R E S O L U T I O N

WHEREAS, in consideration of evidence presented at a public hearing on July 26, 2018, regarding Detailed Site Plan DSP-18017 for JDA Baltimore Avenue, the Planning Board finds:

Crossing improvements at Hollywood Road are recommended in the sector plan:

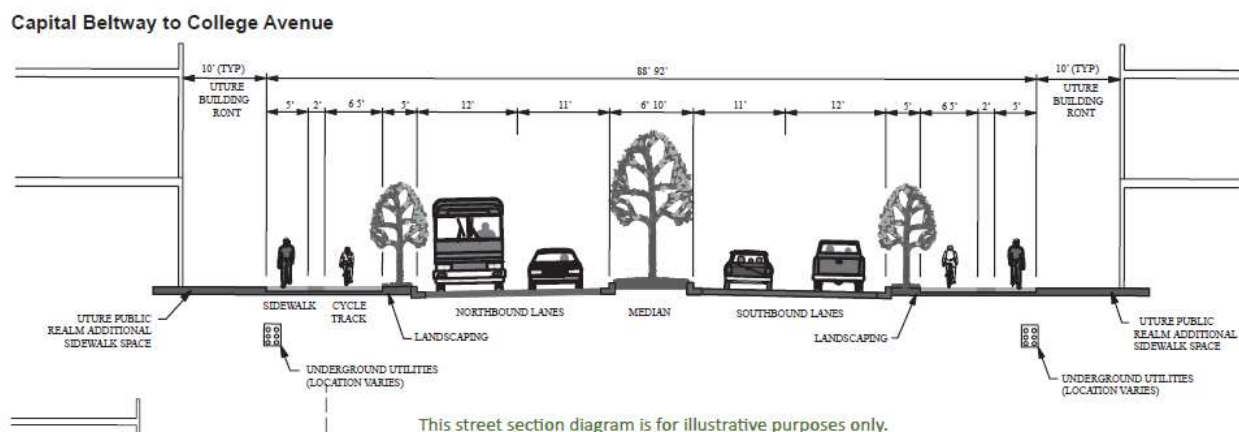
- **Improve the US 1 and Hollywood Road intersection with crosswalks and a traffic light.**

Frontage improvements along US 1 and along the internal roads/drive aisles abutting the subject site should be consistent with these standards.

While the applicant has agreed to reflect the limit of the shared bikeway along the southern property boundary, it has not been reflected in the DSP, and should be. The applicant must provide updated plans depicting the limit of the shared bikeway along the southern property boundary.
